Access Compliance Report

Public Rights-of-Way

Intersection ID: 6454	Main Street: BRYAN_FURR_DR	Cross Street: SLATER_SPRINGS_DR	Location: NE
ADA ID: ED8E07DAE2EE	Ramp Type: BlendTrans2	Initial Pass/Fail: Fail	Overall Compliance: No
			Severity Score: 21.25

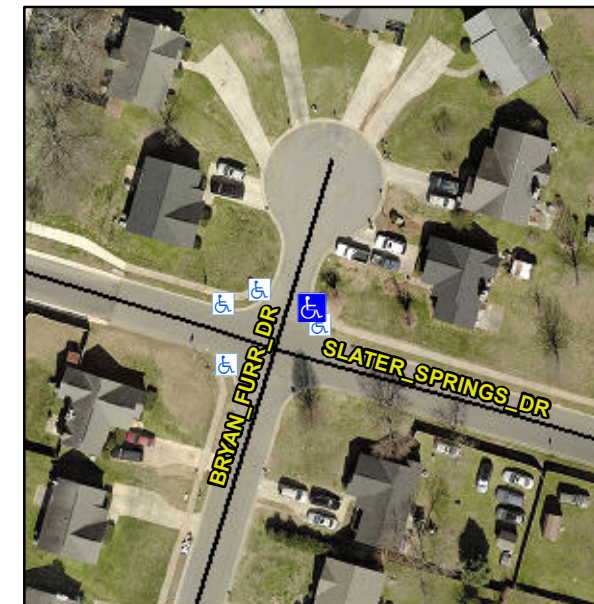
Surveyor Notes:

NO LT SW

PROW/ADA:

Not Found, R304.5.1, R304.5.3

Possible Solutions:

Remove & Replace Curb Ramp With Two New Directional Ramps or Equivalent.
